THE GATHERINGS

SUMMARY

<p>Owner Ralph Ireland Lake Nona Land Co., LLC</p> <p>Applicant Heather Isaacs Lake Nona Land Co., LLC</p> <p>Project Planner Colandra Jones</p> <p>Updated: April 25, 2016</p>	<p>Property Location: The subject property is located south of Tavistock Lakes Boulevard, north of Laureate Boulevard, east of Maskin Avenue and west of Benavente Avenue (±9 acres, District 1).</p> <p>Applicant's Request: Specific Parcel Master Plan (SPMP) and preliminary plat approval for an active adult multi-family development comprised of 216 dwelling units.</p> <p>Staff's Recommendation: Approval of the request, subject to the conditions in this report.</p>	
---	---	--

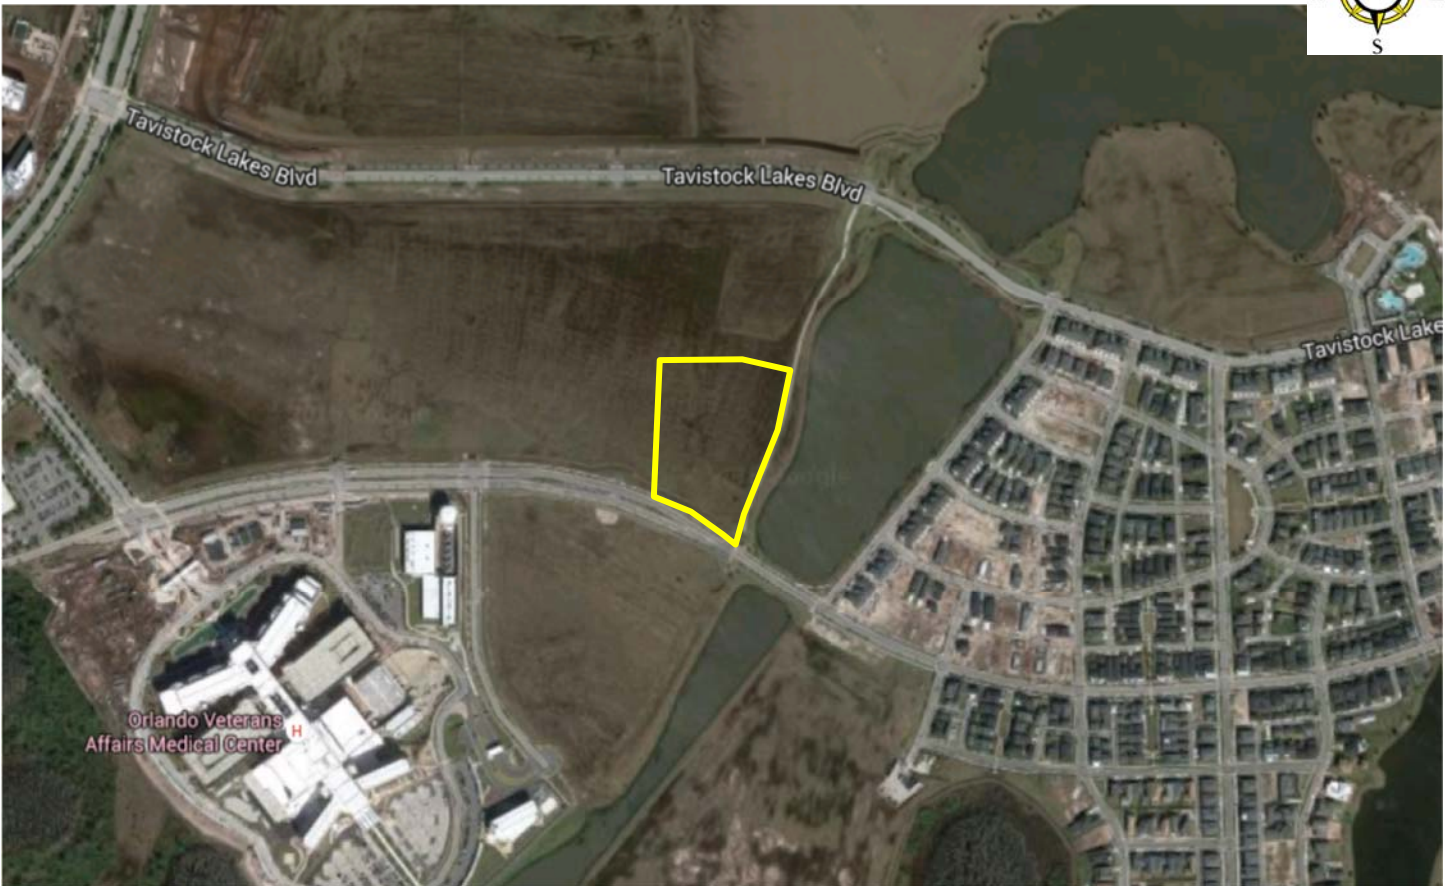
The applicant is requesting an alternative standard to allow for some air conditioning compressor units between the building and the street. In Urban Design Condition #2, staff indicates that the applicant relocate those units between the building and rights-of-way. Provide a minimum 4 foot wall and generous hedges (36" at time of planting) to screen mechanical equipment locations.

Section 58.983(b) prohibits mechanical equipment located between the building and the street. This SPMP approves an alternate standard and allows for A/C units between the building and the street, provided the urban design conditions are met.

Proposed Signage

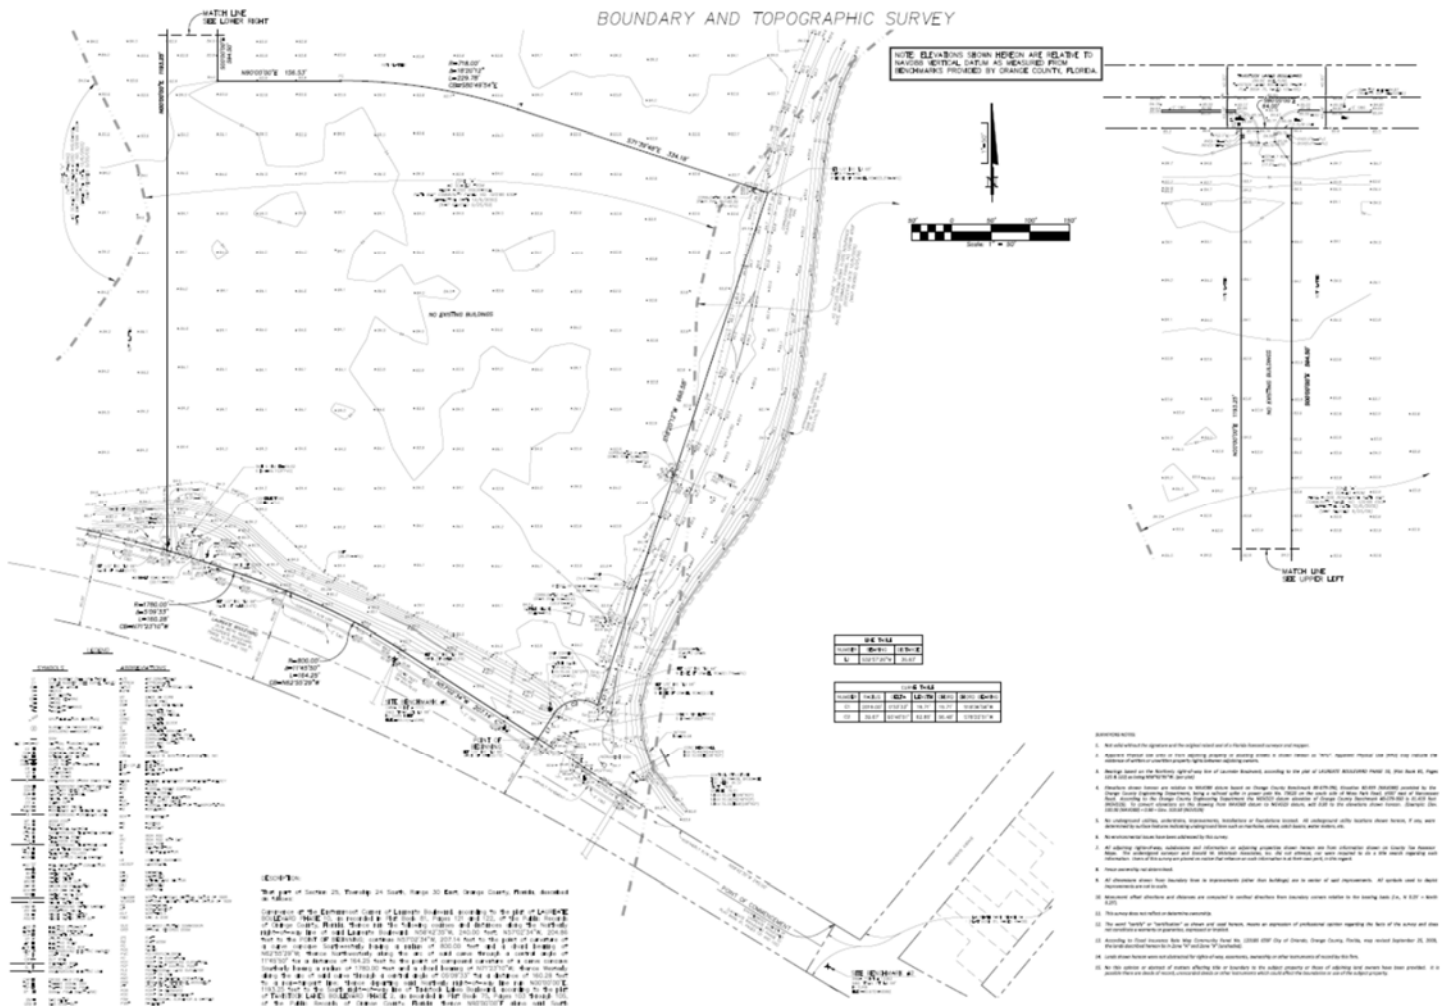
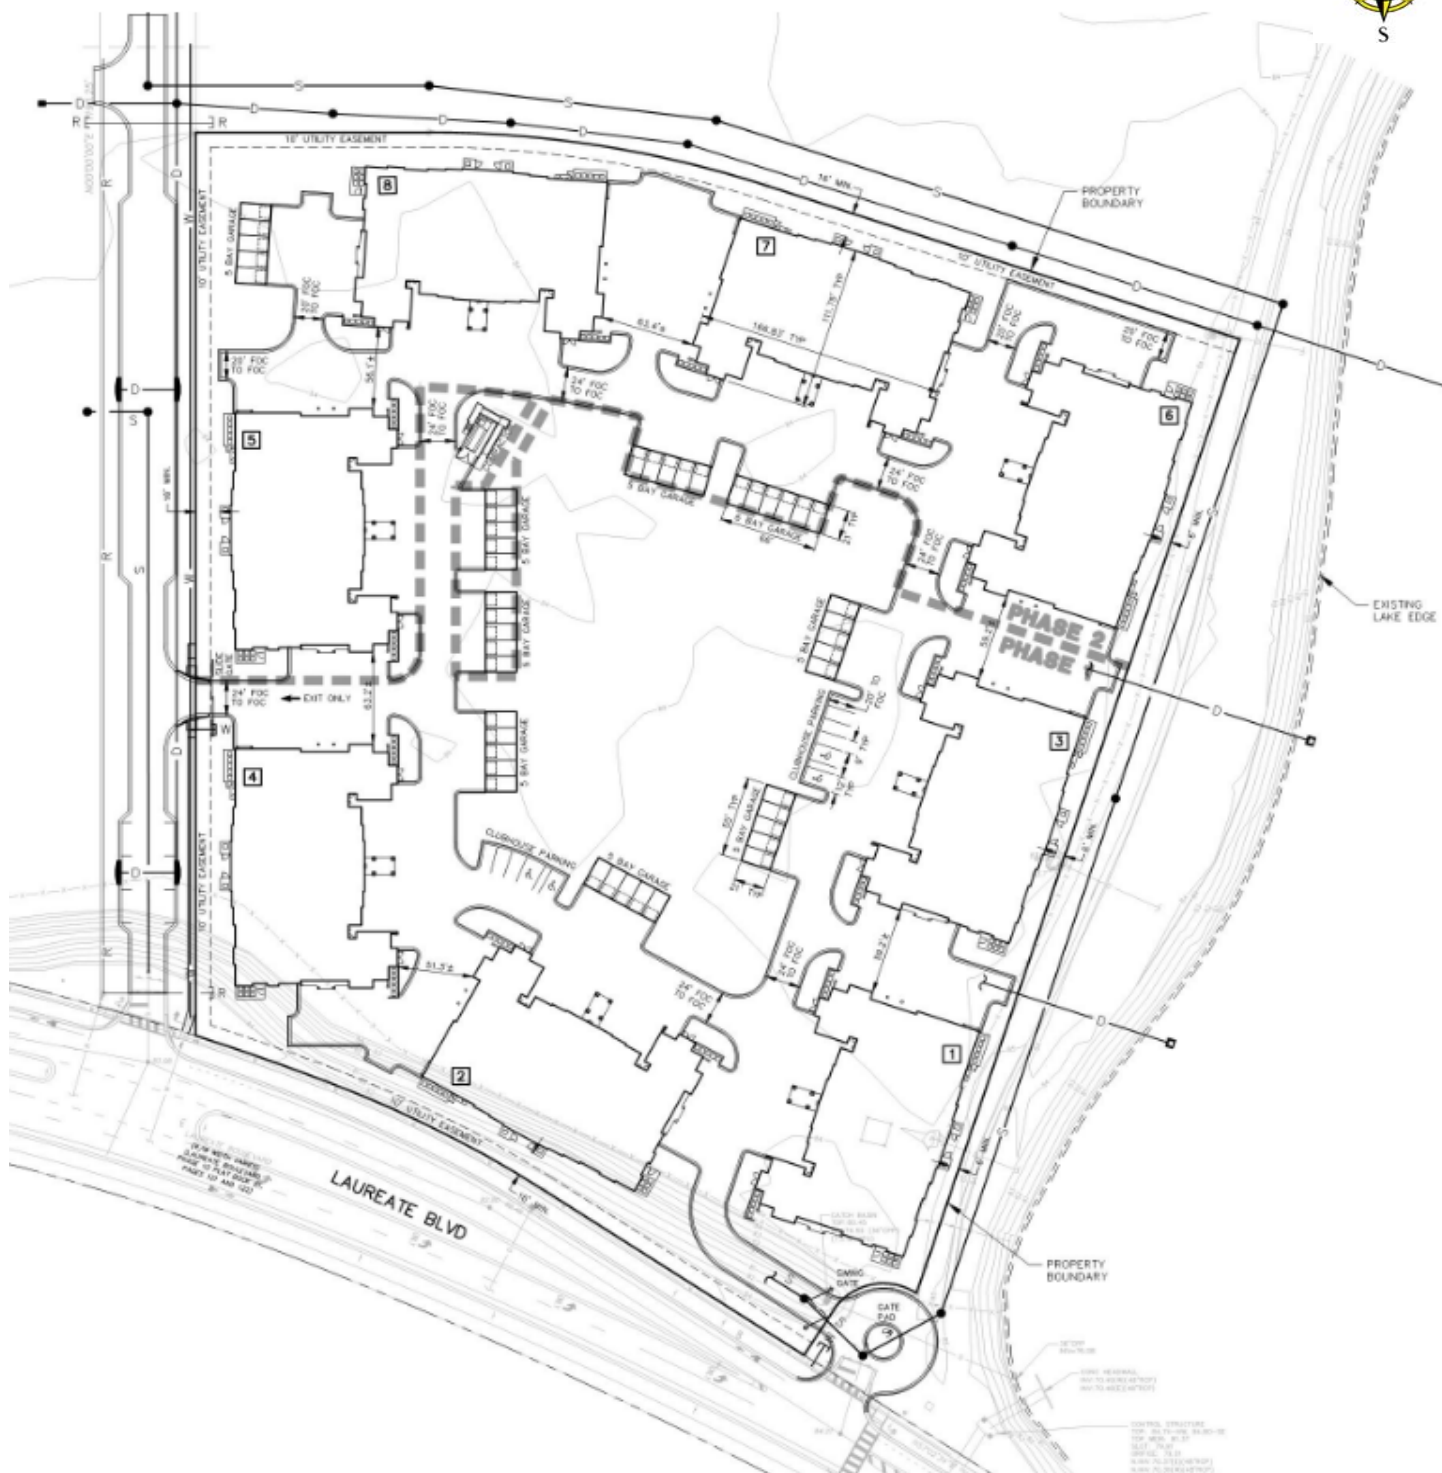
A rendering of the proposed monument sign was submitted with this application (See Page). The proposed signage shall be consistent with Chapter 64 of the LDC and the Lake Nona Master Sign Plan.

The proposed signage shall be consistent with Chapter 64 of the LDC and the Lake Nona Master Sign Plan.

CONCEPTUAL LANDSCAPE PLAN

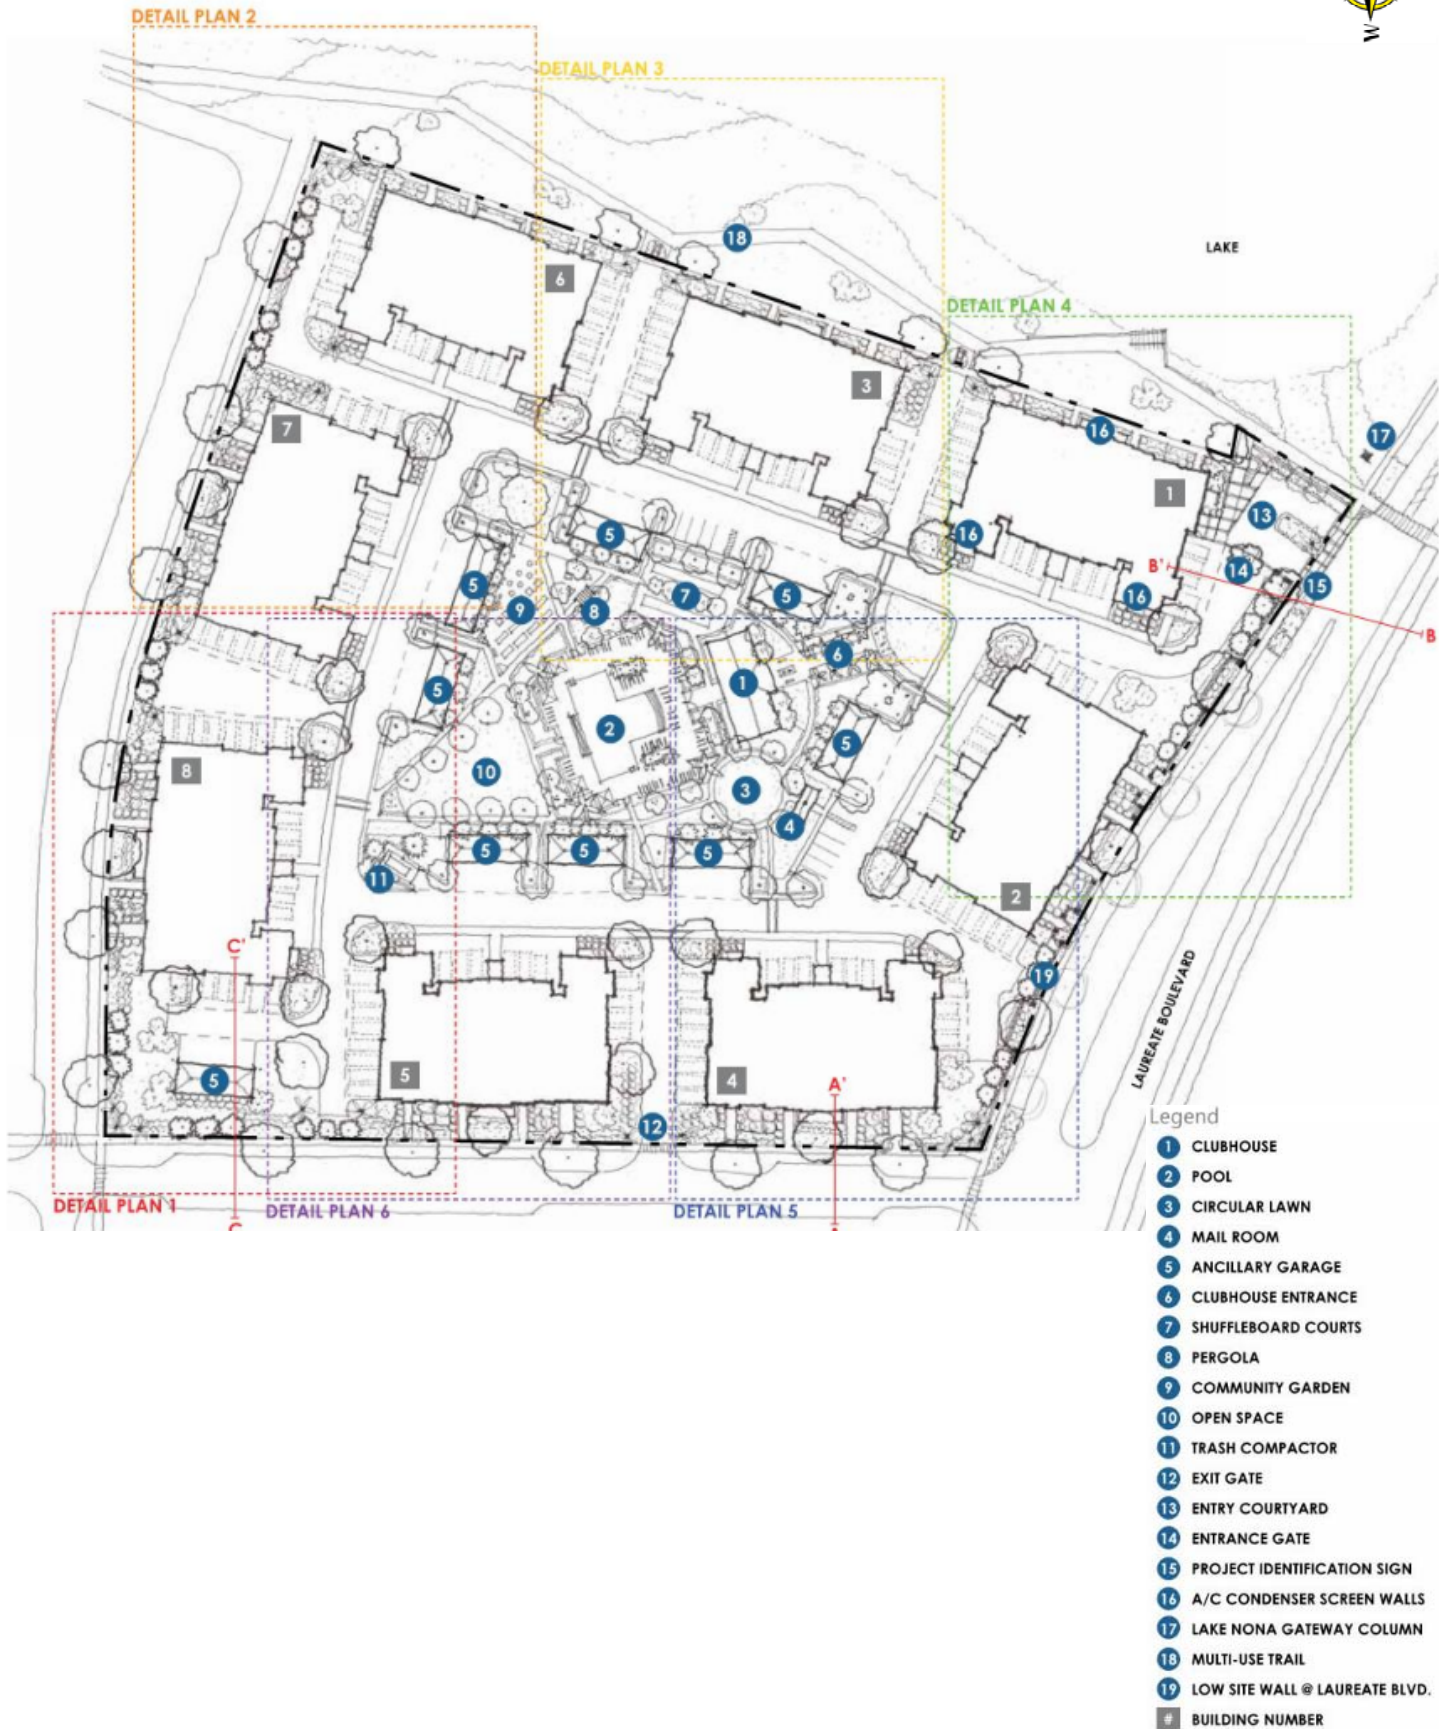
The applicant submitted a conceptual landscape plan with this application. It is noted that the landscape plan will be developed in accordance with Chapter 60. The applicant has also indicated that the landscape plan will utilize the plant palette already established throughout Lake Nona.

The landscaping plan shall be developed in accordance with LDC Chapter 60. A final landscape plan, including plant list, shall be submitted for Appearance Review prior to building permits. The landscape plan shall include the trail and park to the east, and the cul-de-sac to the north.

PRELIMINARY PLAT

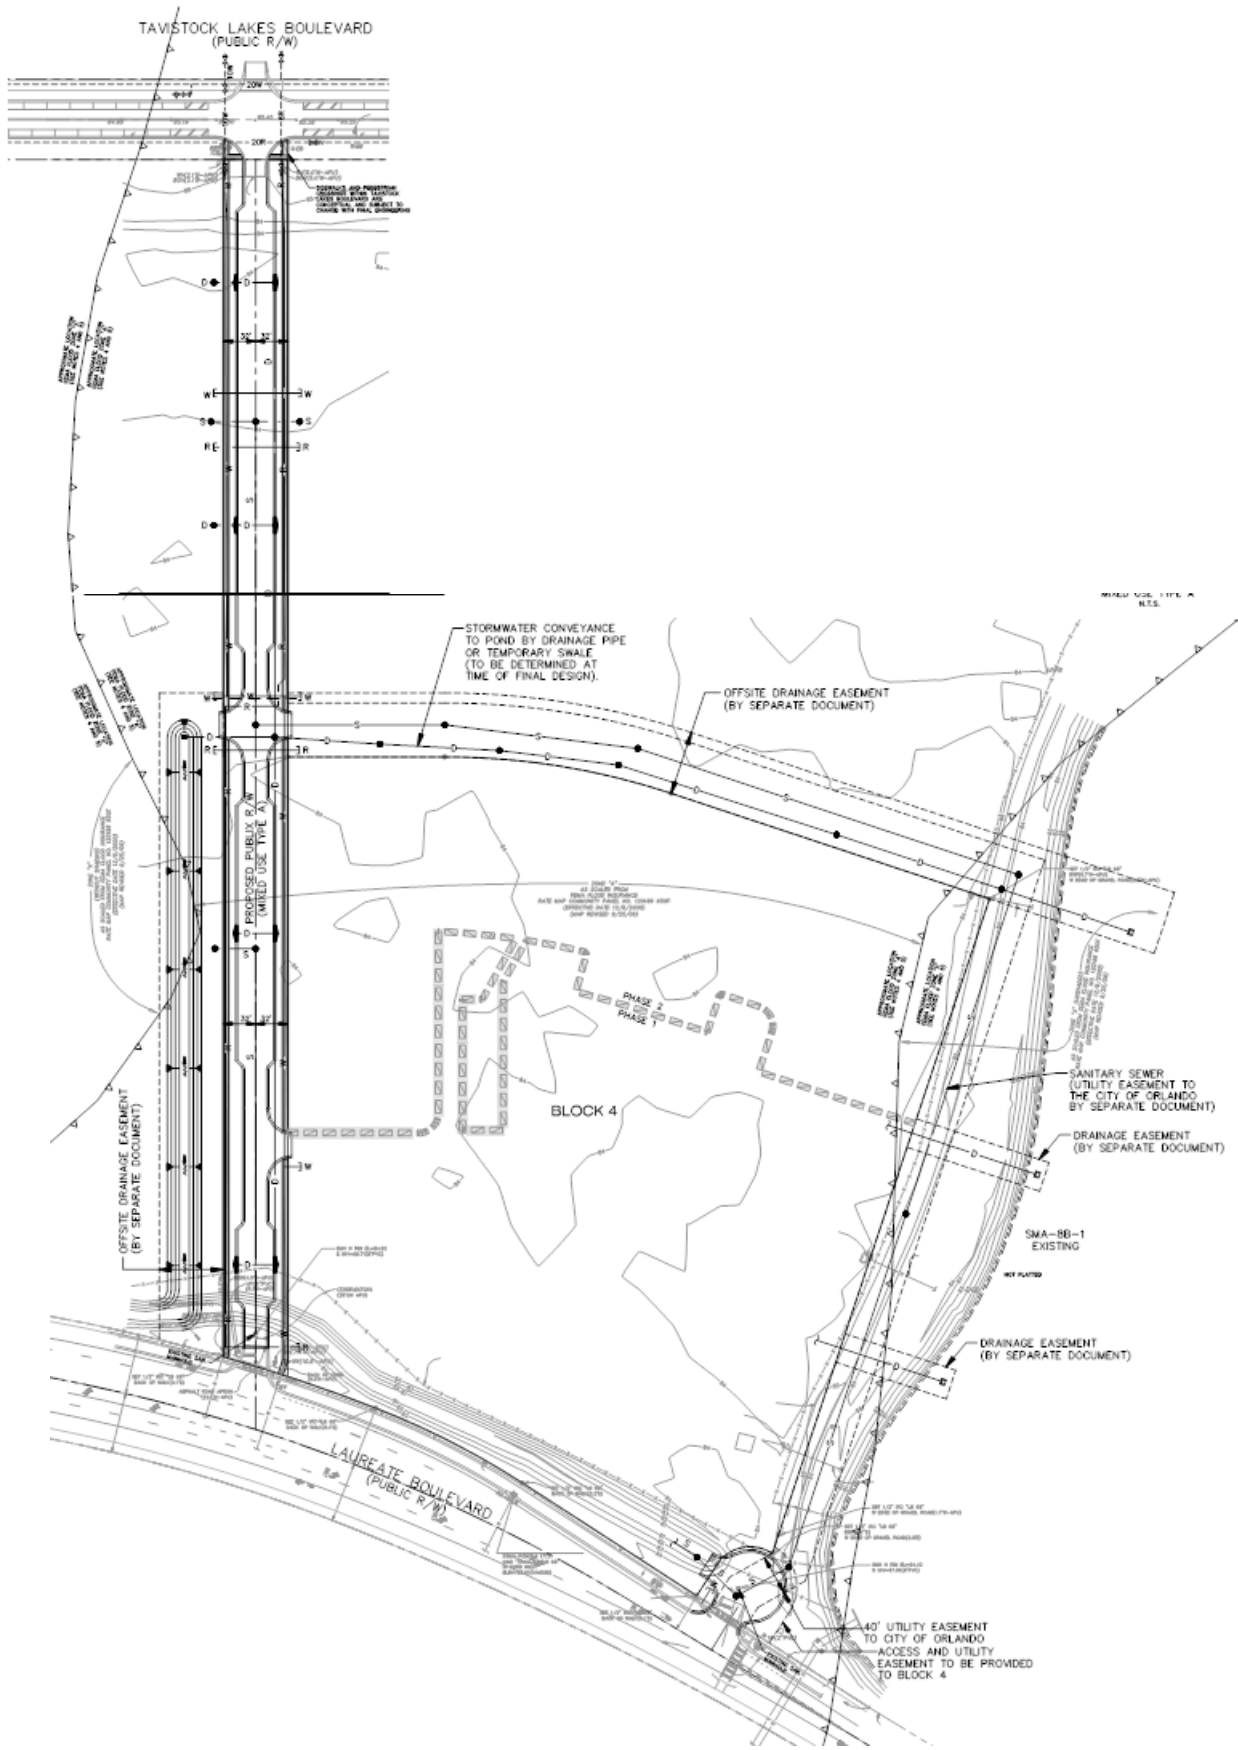
1. The project is in need of a second point of ingress. It is suggested that a second connection could be added to the future street along the northern boundary of the site, provided Building 8 moves further west and the garage at the corner are reconfigured. Or, delete the gating system and provide more even distribution of access.

2. Provide a minimum 4-ft wall and generous landscaping (minimum 36" hedge at time of planting) to screen mechanical equipment locations.
3. There are concerns there is not enough visitor parking provided in this plan. On-Street and unassigned visitor parking should consist of approximately 10% of the parking requirement - please clarify locations of visitor parking and consider additional parking.

7. A connection is needed between the lake "trail" and the continuation of the sidewalk of the northern street's sidewalk to the trail system around the lake.

8. For the northeast and southeast corners of the site, add pergolas or other design treatments, subject to appearance review at time of permitting to soften the appearance of garages facing the right-of-way.

9. An appearance review is required for the park area to the east along the lake. Staff suggests routing the walkway such that it follows the shoreline or is more direct (straight).

9. The overall site plan and cross sections do not provide sufficient information for review, more dimensions and a clearer layout will be required.
10. Shift the entrance off of Laureate Blvd due to the conflicts at the drop lane. Staff suggests Providing an entrance and exit, possibly separate, from the west side of the property.
